AMPIRE CO., LTD

Issue Date	Notification of Product	Last shipping Date	Notification number
2012/8/28	Last order Date		x

Product ID (Description):
AT320240Q4/Q5/Q6 series

Description of change:
The changing of LED dice of B/L

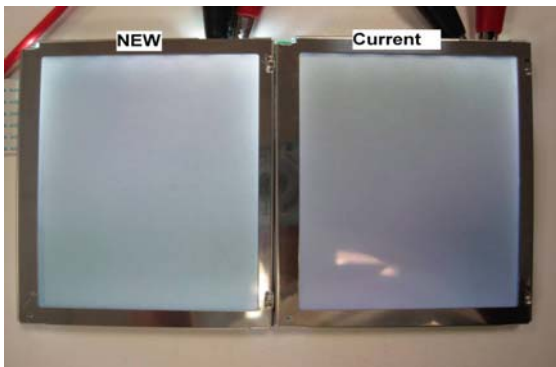
For the parts, due to that the supplier, lighthouse technology Co.,LTD. is not longer able to supply the old LED dice,LH-06034P1-W3D-C43-01, continually,the successorLED dice is the 01.JH.CBEB2ZD-D from JuFei Optoelectronics. The brightness of new successor is high but the color is not the same but the color of B/L is within the specification. please refer to the above comparison.
